FIRE SAFETY INSPECTION REPORT

GOLDEN REFIT GARMENT LTD.

April 23, 2014

Table 1. Findings And Recommendations - Golden Refit Ltd building #2

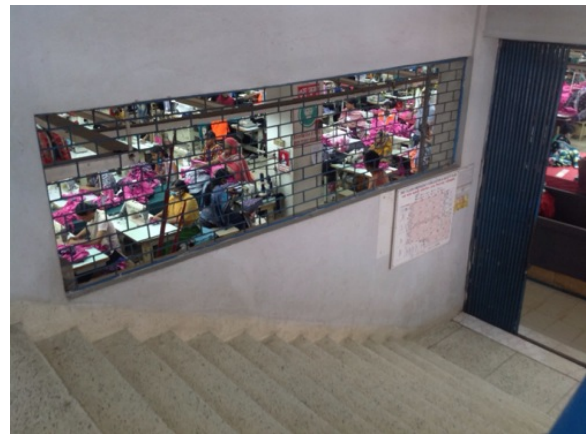
No.	Category	Finding	Recommendation	Remediation Timeframe
F-1	Fire Rated Construction	The exit stairs are not separated from work areas, other spaces on each floor by fire-rated construction.	<p>Provide minimum 1.5-hr fire rated doors and seal all unprotected openings to separate the exit stairs from work areas and other building spaces on all floor levels. Ensure that the fire doors are self-closing and positive latching and that they are provided with fire exit (panic) hardware where serving production floors.</p> <p>If fire doors are required to be held open for functional reasons, provide automatic-closing devices tied to the fire alarm system.</p>	Within 3 months

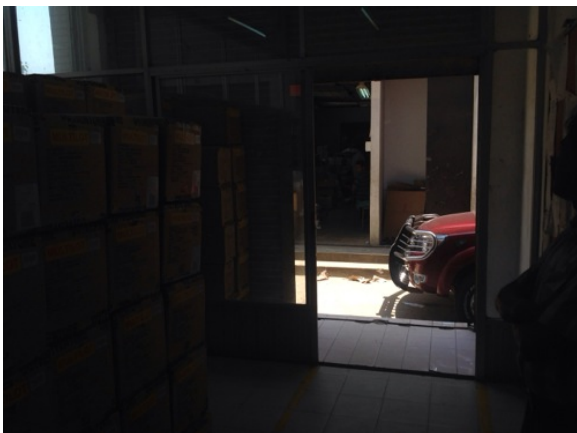
F-5	Egress	Storage was located in the egress path south wall fourth floor and ground floor packing area.	Keep egress paths and stairs clear of storage.	Immediate
-----	--------	---	--	-----------
